Amendments to the Drawings:

OA1_REPLY.DOC PMM / 00-106 July 23, 2003

F/6,15

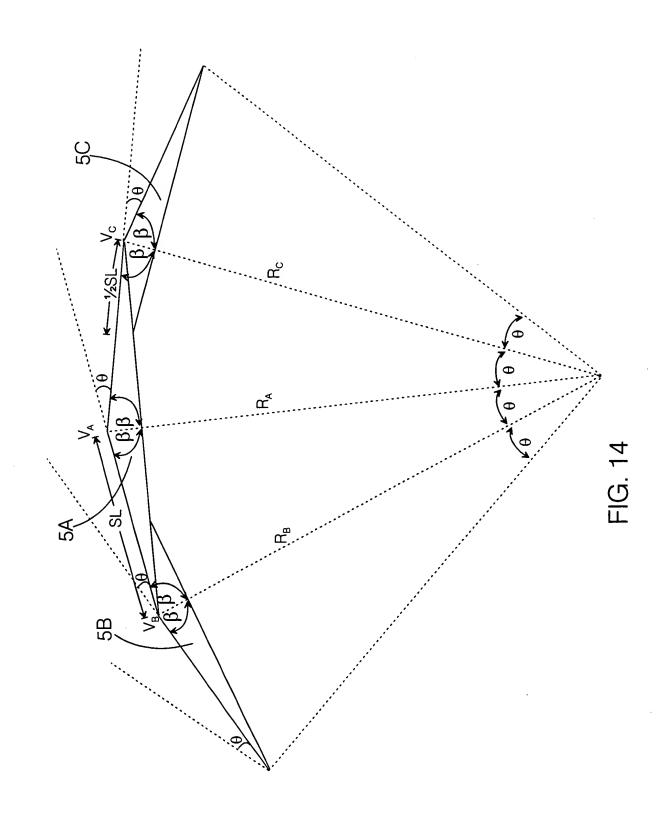
New FIGS. 14, 15 and 16 are added. FIG. 14 is an illustration of overlapping hub

elements 5, showing in greater detail the information shown in FIGS. 4 and 5. FIGS. 15

and 16 illustrate embodiments that were discussed in the Specfication as filed, but not

illustrated. Informal drawings are attached hereto.
